NORTH FALLS

Offshore Wind Farm

Applicant's Response to ExA's Request for further information (Rule 17) - Galloper

Document Reference:	9.90
Volume:	9
Date:	June 2025
Revision:	0

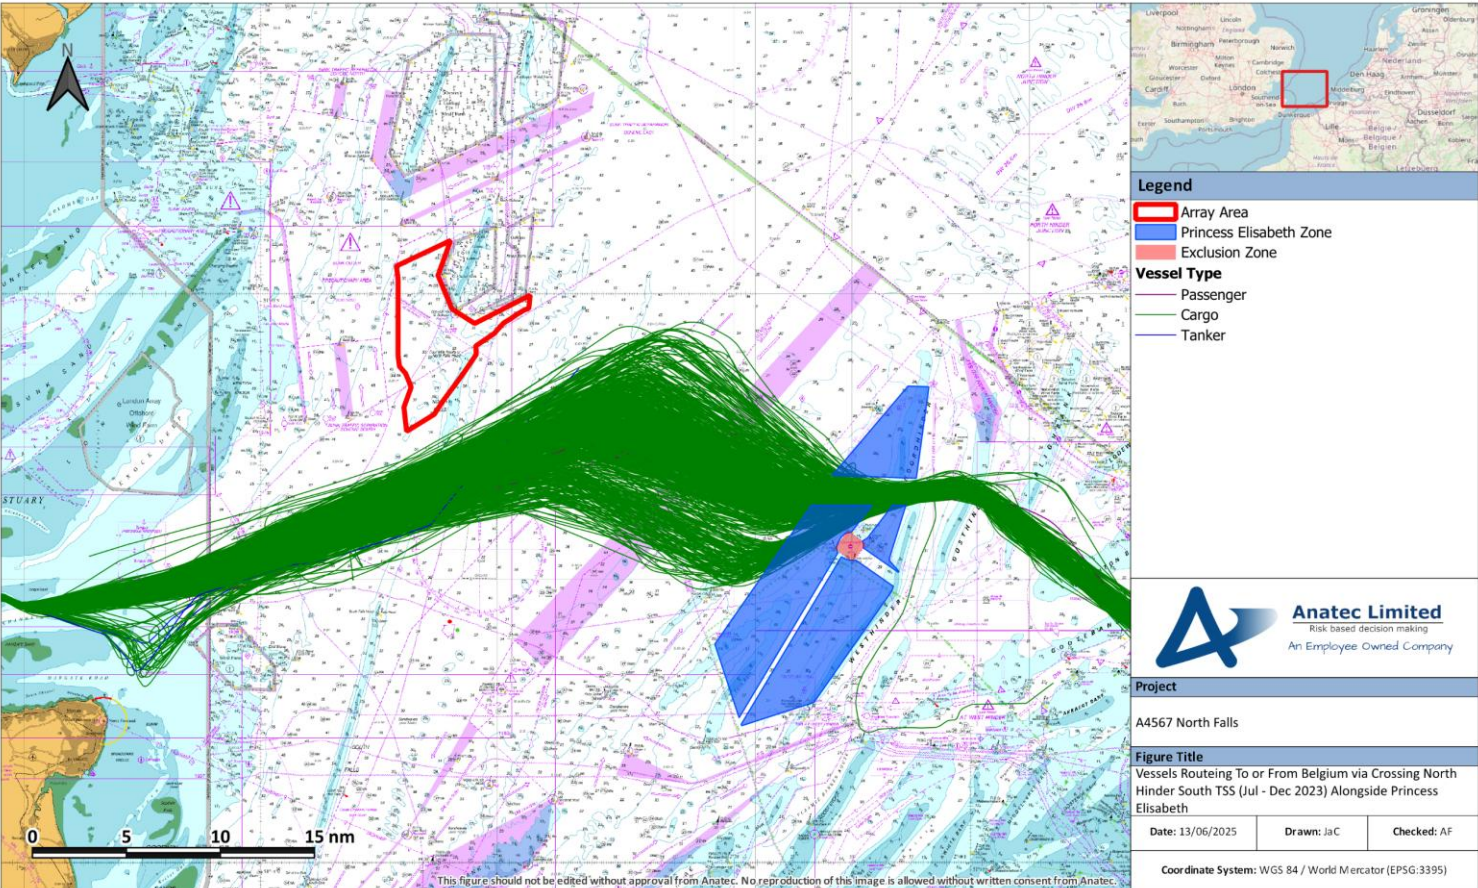
PD-015_b	<p>It is also stated that the Princess Elisabeth Island has already begun construction, and an exclusion zone is in place over the historic (South) route. This is illustrated by the figure below (Figure 4.6 from the FSA [Formal Safety Assessment] [REP2-025]).</p> 	n/a

Ref	Exa Request	Applicant's Response
	<p data-bbox="270 258 1196 289">Figure 5.1 of the FSA [REP2-025] shows the Historic Ostend Routes below.</p>   <p data-bbox="270 1692 1299 1724">Figure 6.6 Routing Constraints – Future Case (i.e., with Princess Elisabeth Zone)</p>	
PD-015_c	<p data-bbox="270 1749 1368 1801">To assist the Secretary of State's and the Examining Authority's (ExA) understanding of this matter, the Applicant is requested to respond to the following points:</p> <ol data-bbox="270 1808 1368 1877" style="list-style-type: none"> Given that the future case route in Figure 6.6 (above) between the south of the Princess Elisabeth Zone (PEZ) Area 1 and the north of the PEZ Areas 2 and 3 appears similar to the historic Gallopier recommended route (North route) shown in Figure 5.1 above, the ExA requests that the Applicant confirms whether these 	<p data-bbox="1412 1749 2807 1850">The Applicant can confirm that the "Gallopier Recommended Ferry Route" 'Historic (North)' route shown in Figure 5.1 [REP2-025] is similar to the future case route in Figure 6.6 [REP-2025]. However, the Applicant can confirm that the most frequently used route was the 'Historic (South)' route, with the 'Historic (North)' route used only occasionally by the ferries from Ostend, likely under certain tidal or meteorological conditions.</p>
